Berhampore to Newtown cycleway audit - safety and accessibility

90% design audit

Paneke Pōneke
Bike network plan

April 2023

Figure 4-2: Bus stop 6123

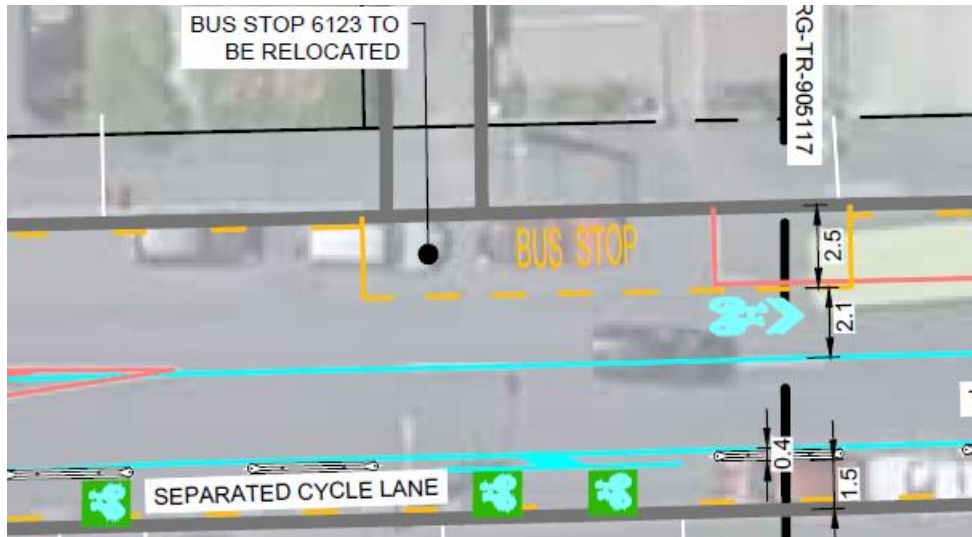
There are several bus stop locations where the adjacent traffic lane is significantly narrower than the legal minimum lane width of 2.5 m:

The safety issue is that drivers may assume they have enough space to pass the bus when they in fact do not.

The relevant legislation is the definition of lane in the Land Transport Road User Rule, which specifies 2.5 m minimum. The [Bus Stop: Public Transport Design Guidance](#) (section 4.4.2) prescribes a 1.5 m minimum gap between the bus stop cage and the lane line, although this is contradicted in subsequent text, which stipulates 1-1.5 m. The guide does not discuss the problem of wider gaps that motorists may attempt to drive in.

Figure 4-3: Sharp lateral shift on Luxford Street

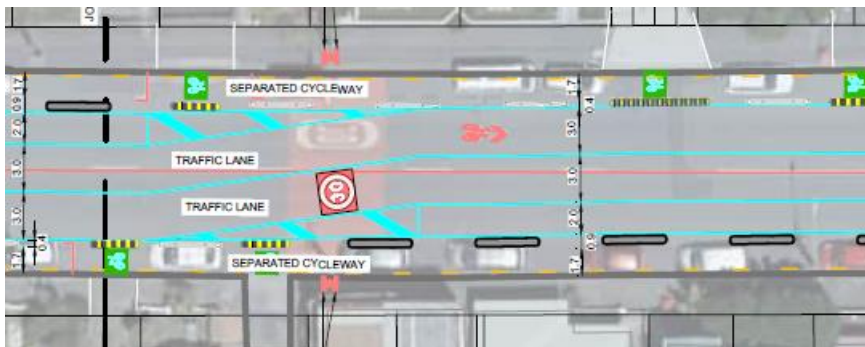
There are several locations where the traffic lanes undergo a sharp lateral shift. For example, on Luxford Street at the 30 km/h threshold:

The lateral shift appears to be approximately 2.25 m (this should be confirmed via CAD). In a 30 km/h zone, the taper length should therefore be approximately 31 m, as per the TCD Manual under “edge lines at abrupt changes in width” (see Equation 1); however, only 17 m is provided.

Additionally, the proposed lateral shifts have been checked for tracking of buses and are not expected to pose safety risks. Client to address this matter in the council's Monitoring Plan.
Safety Engineer	Agree with CASA findings and disagree with Designer to monitor as the shorter taper will cause vehicles to encroach into adjacent lanes as the operating speed is higher. Tapers should be extended.
Proposed client action	Agree with CASA and suggest lengthening hatched area back to black map boundary line on drawings on east side (left of drawing) and a similar distance on the west side although we note the minor impact on parking.
Action taken

Figure 4-4: Riddiford bus stop / loading zone / cycle lane arrangement

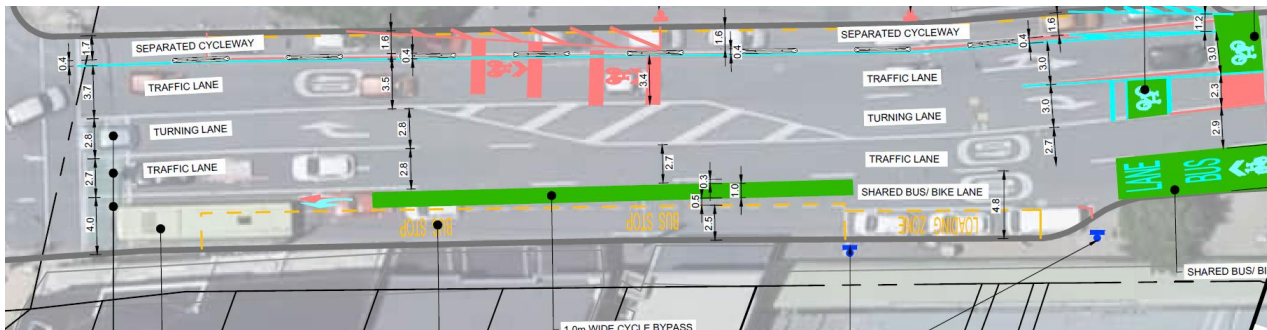
The arrangement shown in Figure 4-4 is an improvement on the previous design; however, there are still some safety issues:

Designer	<p>Agree with CASA findings and recommendations.</p> <p>The relocation of the bus stop box to a more southerly position is supported in order to provide adequate space for both cyclists and motorists between the limit line and the end of the bus stop box. This adjustment aims to enhance the safety of the left turn lane, facilitating its use by both vehicles and cyclists. This repositioning would result in a reduction in the length of the loading zone so it can accommodate one vehicle.</p> <p>It has been observed that a vehicle occupying the loading zone may impede bus access to the start of the bus stop, thereby decreasing its overall effectiveness. However, it has been noted that the loading zone is scheduled to be time-restricted from 9:30 am to 3 pm, thereby avoiding potential issues during peak periods. During off peak periods the full bus stop length will not be required and there is sufficient lead in to the head of the stop.</p> <p>Additionally, the green paint marking will be extended from the loading zone to the end of the bus stop box.</p>

Safety Engineer	Agree with CASA findings and primary treatment recommendations and the Designer to provide a revised layout for further review.
Proposed client action	Agree with designers proposed treatments.
Action taken

Figure 4-5: Phasing diagram for Riddiford / Rintoul

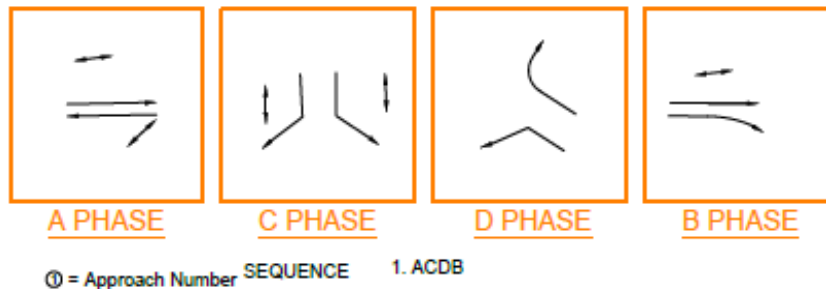
Figure 4-5 shows the phasing for Riddiford / Rintoul; there is no partial pedestrian protection provided at the intersection. The 10-year crash history includes three crashes involving pedestrians, but these all appear to be due to pedestrians attempting to cross during the wrong phase.

The safety issue is that turning motorists may not realise they have to give way to crossing pedestrians, due to the unusual angle of some legs.

Figure 4-7: Start of southbound cycleway on Rintoul Street

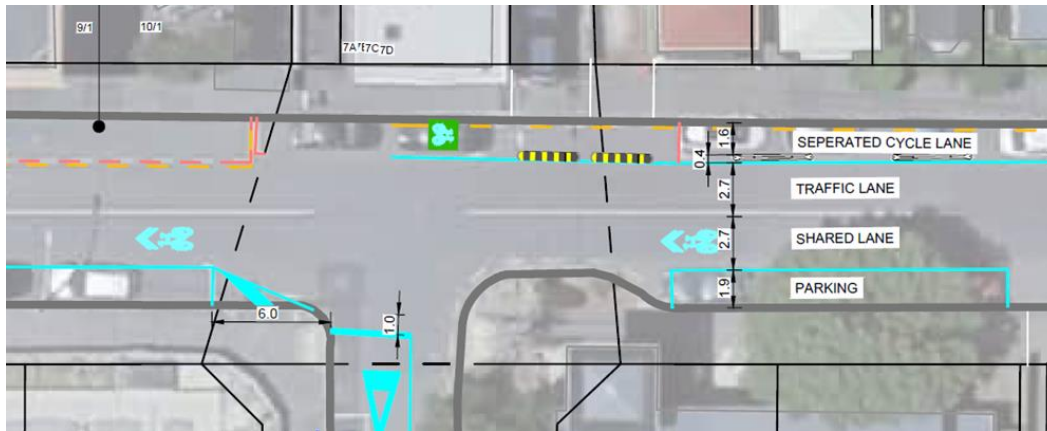
The safety issue is insufficient indication to cyclists regarding the commencement of the southbound separated cycleway on Rintoul Street (see Figure 4-7) – cyclists may not realise they are expected to use the cycleway and instead continue sharing the narrow general traffic lane in the uphill direction.

The crash types expected are cyclist vs motor vehicle or cyclist v bus.

Figure 4-9: Rintoul Street passing area

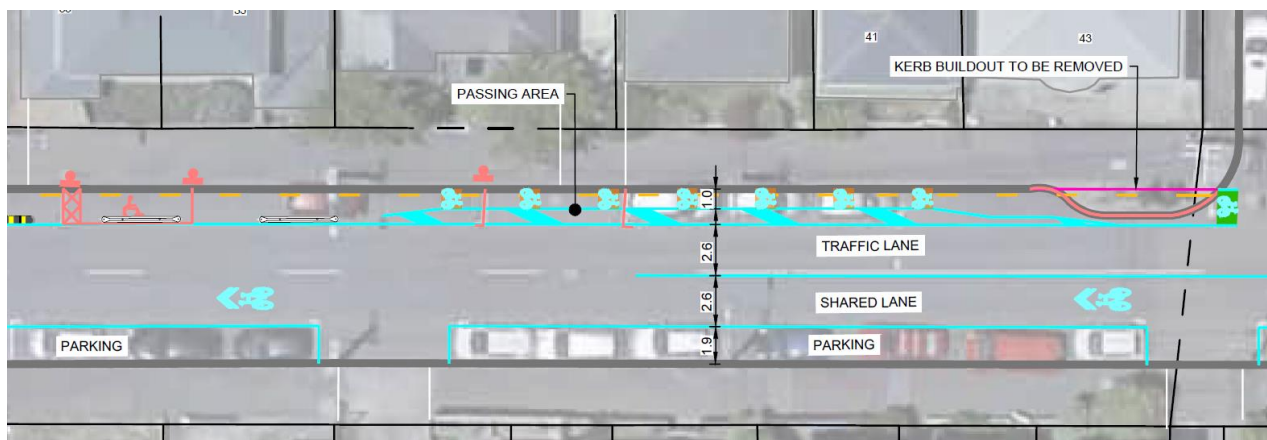
Figure 4-9 shows an example of one of the passing areas planned on the north (uphill) side of Rintoul Street. The design decisions report indicates that this is to provide space on the narrow carriageway when there is a bus (or other large vehicle) travelling in either direction.

The safety issue is that the passing area creates a cycle lane of 1.0 m, which is too narrow for cyclists travelling immediately adjacent to buses. It is also noted that the 1.0 m is measured to the kerb face, i.e. it includes the gutter, which is not always in cyclable condition along the route. The chevron area (0.8–0.9 m) is not dedicated cycling space and will not be physically available to cyclists if being used by a bus (or any

Probability of crash occurring	Unlikely
Expected crash severity	Serious injury
Primary treatment recommendations:	
4.13.1	Provide localised lane widening by removing parking on the other side of the road.
Supporting treatment recommendations:	
At the very least, if the passing areas in the cycleway are to be retained:	
4.13.2	Confirm treatment style with Waka Kotahi. In particular,

<p>distance and pull over safely to let them pass.</p> <p>The proposed passing areas include the bus stops, which can serve as a safe spot for opposing buses to pass each other. Additionally, the design proposes to use the areas in front of condensed driveways and remove some parking spaces to provide passing areas.</p> <p>Four passing areas in the southbound direction and the only passing area in the northbound direction are proposed to be removed. Instead, the following locations are considered as safe spaces for two large vehicles to pass in opposite directions:</p> <ol style="list-style-type: none"> 1- Northbound direction – In front of properties 120-124 Rintoul Street. This area is around 40m long. 2- Northbound direction - Remove one parking space in front of 104 Rintoul Street Rintoul Street. This area is around 30m long. 3- Northbound direction - Removal of two parking spaces in front of 38 and 40 Rintoul Street. This area is around 37m long. <p>No line or pavement marking is proposed at the new passing areas, apart from no-stopping line marking, to prevent other vehicles from using the areas as a place to stop or park.</p> <p>Client to comment on the removal of three parking spaces to provide passing areas.</p>

Safety Engineer	Agree CASA findings and primary treatment recommendation with the revised passing areas to be further reviewed. I am unclear what is meant by the Designer in stating: “No line or pavement marking is proposed at the new passing areas”. The proposed passing areas are to be reviewed again.
Proposed client action	Removing the passing areas as outlined by designers and further review at 90% TR issue drawings.
Action taken

Figure 4-10: Rintoul / Te Wharepouri intersection layout

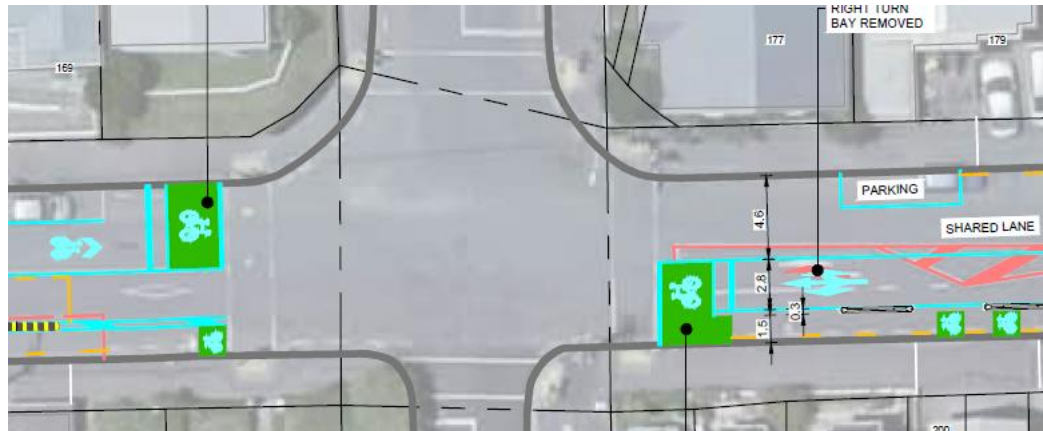
The 90% design (see Figure 4-10) removes the right turn bay from the Rintoul Street south approach to Te Wharepouri Street, and creates a lane shared by left turning, through and right turning traffic. This is adjacent to a kerbside separated cycle facility.

4.14.1 Remove parking on the east side of the north approach so the north approach lane is against the kerb and establish right turning bays in the centre of the intersection. (This, however, will not lead well to the planned future southbound separated cycleway.)

Ideally, the right turn from the south approach should be banned, but it is understood from the 30% CASA that this is not considered feasible. The recommendations therefore provide alternatives assuming the right turn must be retained.

Proposed client action	Install additional separator and add continuity lines to highlight the left turn conflict (least common movement at this intersection). Add an advance cycle light and/or advance northbound light in the morning peak which allows northbound traffic to move ahead of southbound traffic and should help to clear both right turners and straight ahead traffic. LGWM Modelling shows that going to one lane northbound and R turn has minimal effect on the operation of the intersection and traffic queuing.
Action taken

Figure 4-11: Cycle lane on inside of bend at Luxford / Rintoul

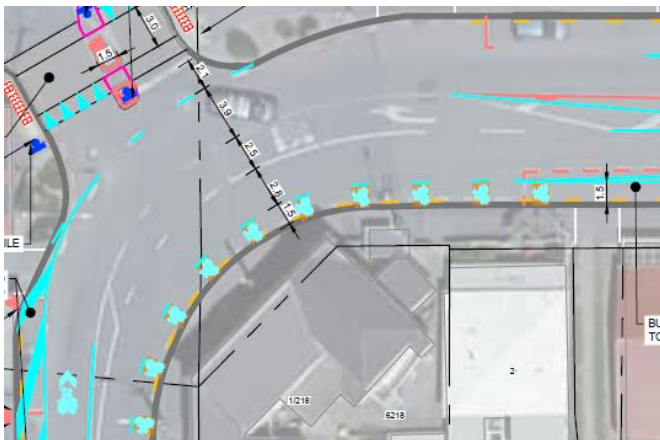
Figure 4-11 shows the cycle lane on the inside of the bend at Luxford / Rintoul Street. Since the 30% plans, the width of the cycle lane has been narrowed and red coloured surfacing (see also issue 4.4) has been added under the cycle symbols.

The safety issue is motor vehicles are expected to cut the corner and encroach on the cycle lane.

Probability of crash occurring	Unlikely
Expected crash severity	Serious injury
Primary treatment recommendations:	
4.15.1	The only way to fully mitigate this would be to provide physical separation around the corner.
Supporting treatment recommendations:	
4.15.2	Apply audio tactile pavers (ATP) around the bend on the lane line to deter motorists from cutting the corner.

Figure 4-13: Luxford / Milton / Rintoul intersection

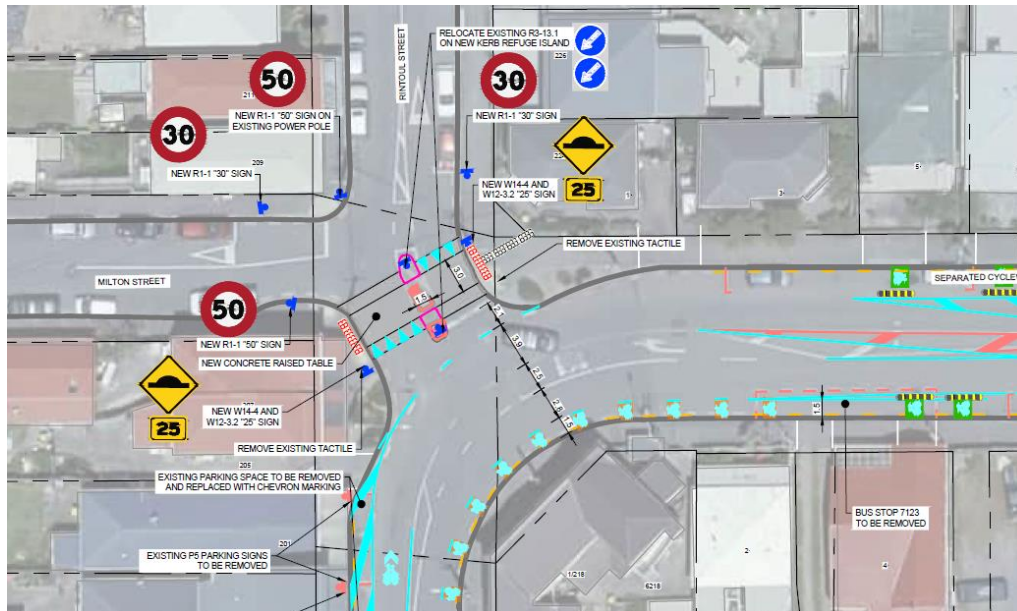
The raised safety platform at the Luxford / Milton / Rintoul intersection (see Figure 4-13) has been designed as a pedestrian courtesy crossing. The safety issue is this will create ambiguity - most drivers are likely to wait for pedestrians, but some will not.

The safety issue is the refuge island on the Milton Street side of the RSP proposed at the Luxford / Milton / Rintoul intersection (see Figure 4-13) will prevent vehicles from turning right out of Milton Street.

Designer	We agree with CASA recommendation. Due to the complex nature of the intersection, a refuge island was originally designed to provide protection and shelter for pedestrians crossing Rintoul Street. To facilitate right turns from Milton Street, the refuge island on the south side of the platform should be omitted. This exclusion does not compromise pedestrian safety since there is adequate visibility from the eastern side of the crossing to the northbound direction of Rintoul Street. Furthermore, the geometry of the refuge island on the northern side should be upgraded to accommodate northbound movements on Rintoul Street and to allow for the installation of an R3-13.1 sign facing the northbound direction of Rintoul Street.
Safety Engineer	Agree with CASA primary treatment recommendation and agree with Designer response.
Proposed client action	Agree with CASA, Designer and safety engineer.

Figure 4-14: Slip lane onto Adelaide Road

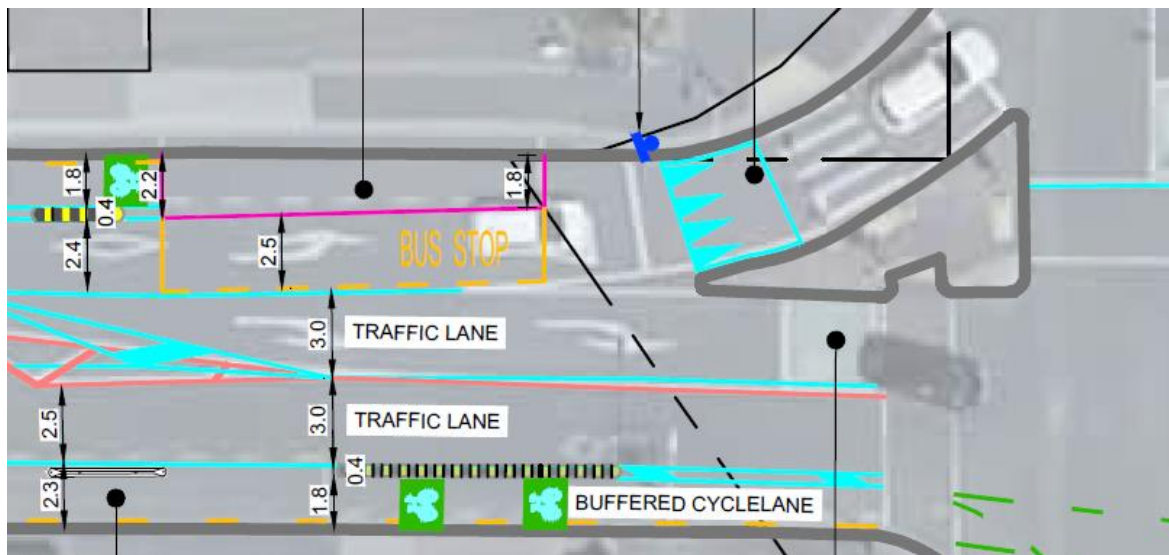
The safety issue is westbound cyclists on Luxford Street will traverse the bus stop platform then immediately have to merge with general traffic prior to or on the slip lane to Adelaide Road (see Figure 4-14).

There are no specific standards relating to this issue. Best practice would be placing sharrow at, and just prior to, the merge location, but it is not possible to provide these due to the proximity of the bus stop and the slip lane ramp.

Safety Engineer	<p>Agree with CASA findings but as the bus stop location is unclear at this stage, I cannot comment further from a safety perspective.</p>
Proposed action	<p>Bus stop will not become a platform bus stop and will remain kerbside, cycle transition moved back as per designers recommendations</p>

Figure 4-15: Bus stops on Adelaide Road between Luxford Street and Britomart Street

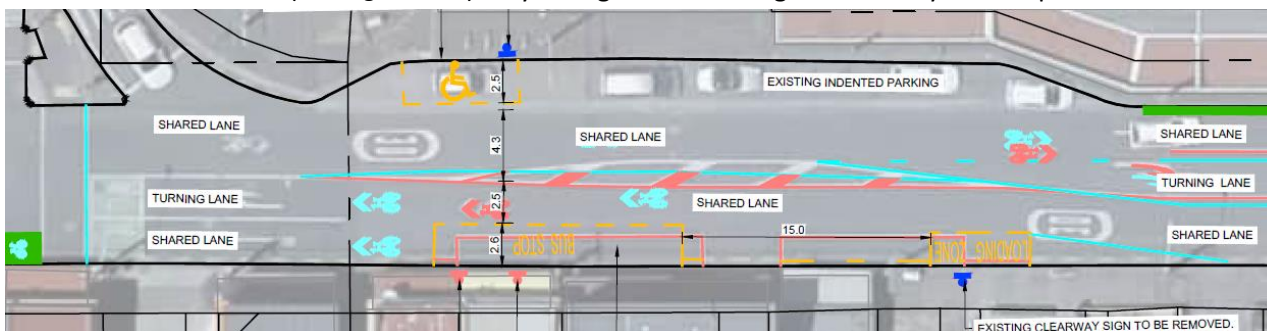
We are aware that the locations of the bus stops in the vicinity of the Adelaide / Luxford and Adelaide / Britomart intersections (see Figure 4-15) may change due to changes in the City Streets plans.

As currently proposed, the bus stops on Adelaide Road between the two intersections are shown as being right against the existing kerb; in reality, it will not be possible for buses to park right up against the kerb as they would hit the adjacent power pole and verandas.

Probability of crash occurring	Unlikely
Expected crash severity	Serious injury
Primary treatment recommendations:	
4.20.1	Provide a cycleway bus platform and shift the bus stop out so it becomes an in-lane stop that blocks all general traffic. This would be subject to modelling, especially given short block length between Luxford Street and Britomart Street.
Supporting treatment recommendations:	
4.20.2	N/A

Safety Engineer	Agree with CASA findings. Agree with Designer traffic modelling outcome and the proposal outlined above.
Proposed client action	Agree with designer proposed response.
Action taken

Figure 4-16: Jug handle (hook turn box on footpath) provision for Adelaide Road to Luxford Street

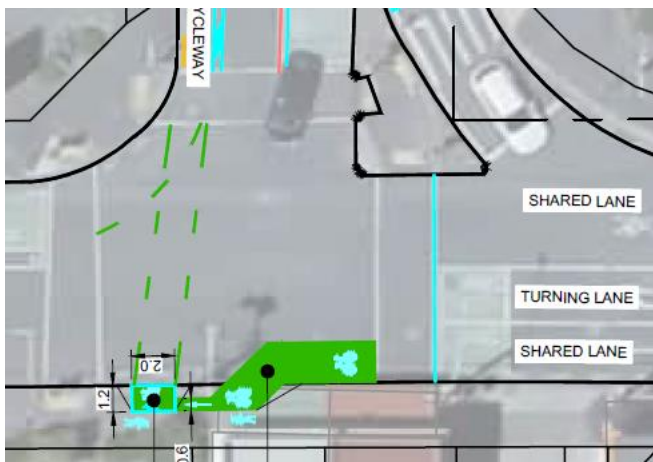
Figure 4-16 shows the jug handle (hook turn box on footpath) provision for cyclists turning right from Adelaide Road to Luxford Street; there are three associated safety issues:

4.21.1 Remove most of the section of green on-road that looks like a marked cycle lane – leave a short on-road section leading to the footpath section.

Responses:	
Designer	<p>Agree with CASA findings.</p> <p>As a result of these findings and other feedback received regarding the 90% design, a redesign of the area is being planned prior to the submission of the Traffic Resolution (TR) design. The current width of the footpath surrounding the proposed hook-turn box is 2.5m. However, allocating 1.2m of this width to the hook-turn box would result in only 1.3m remaining for the footpath, which falls below the absolute minimum width requirement of 1.5m for footpaths. Since it is not possible to occupy more space from the footpath, a kerb extension will be considered to improve the design of the hook-turn box in the TR submission.</p> <p>Furthermore, the continuity line markings for the left turn from the Adelaide Road north approach will be updated accordingly.</p>
Safety Engineer	Agree with CASA findings and agree with Designer response to redesign this area.

Proposed client action	Agree with CASA and Designer. With bus stop placement on this town centre section of road and removal of bus stop north of here a better hook turn design is possible and will be added to the TR issue designs.
Action taken

Figure 4-17: Riddiford / Rintoul traffic signal cable run

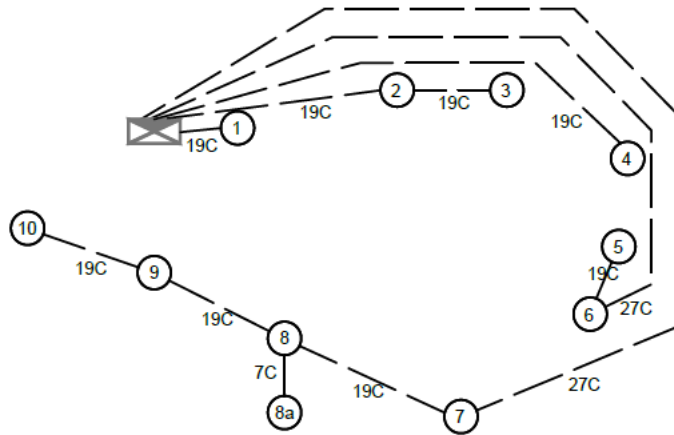
The safety issue is one of the cable runs (see Figure 4-17) includes poles 7, 8 and 9 – which contain all the signal faces for the Rintoul Street approach. If pole 7 were to be hit by an errant vehicle, there would be no signals for Rintoul Street and the controller should shut the intersection down (i.e. go into flashing yellow mode). Drivers would have to negotiate the intersection among themselves and there would be risk of crashes.

Probability of crash occurring	Very unlikely
Expected crash severity	Serious injury
Primary treatment recommendations:	
4.22.1	Introduce redundancy to the cable runs
